UNITED STATES PATENT AND TRADEMARK OFFICE

APPLICATION NO.	FILING DATE	FIRST NAMED INVENTOR	ATTORNEY DOCKET NO.	CONFIRMATION NO.
10/564,658	01/13/2006	Hans-Helmut Bechtel	DE0300247	9677

<p align="center">Office Action Summary</p>	Application No. 10/564,658	Applicant(s) BECHTEL ET AL.	
	Examiner Matthew W. Such	Art Unit 2891

DETAILED ACTION

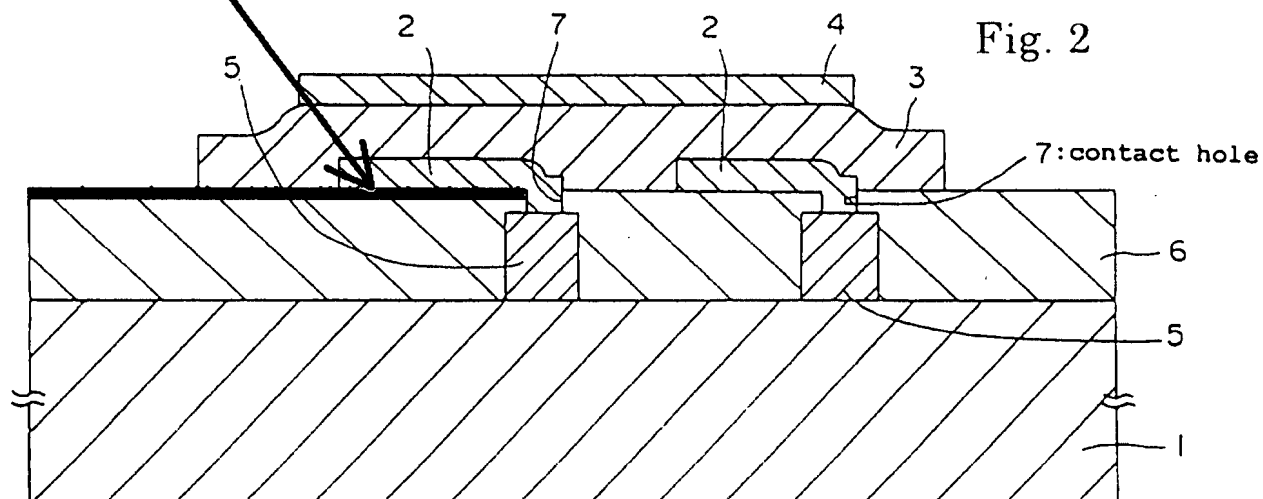
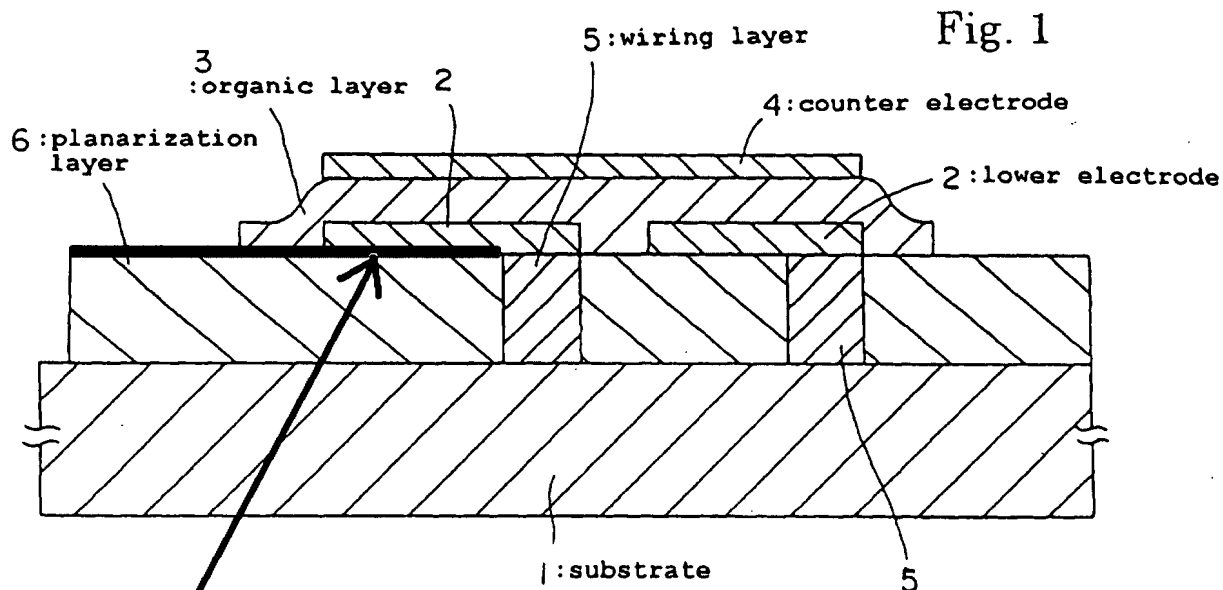
Hosokawa teaches an electroluminescent device having a substrate (Elements 1 and 6 in combination), a metallic structure (Element 5) incorporated into the substrate, and “a layer assembly” with a first electrode (Element 2), an electroluminescent layer (Element 3), and a second electrode (Element 4). The metallic structure, which can be strips (Figs. 2 and 13, for example), is in electrical contact with the first electrode (Figures). The resistance of the metallic structure is lower than the layer resistance of the first electrode (see, for example, Abstract, Disclosure of Invention Sections) and that the metallic structure thickness is greater than the thickness of the first electrode (see, for example, Figs. 1 and 2). The Examiner notes that the manner in which the claim is written does not limit the structural relationship between “the surface” of the substrate and the metallic structure and any surface can be arbitrarily selected so long as “the layer assembly” is formed on “the surface” (for example, the Examiner chooses the surface to be the interface between Elements 2 and 6 as “the surface”):

Furthermore, Hosokawa teaches that the metallic layer (Element 5) does not protrude above the lower electrode and is implanted in the substrate (Page 5, Lines 54-55). Since "the surface", is defined, for example, as shown above, the metallic structure covers none (which is not more than 10%) of "the surface" of the substrate.
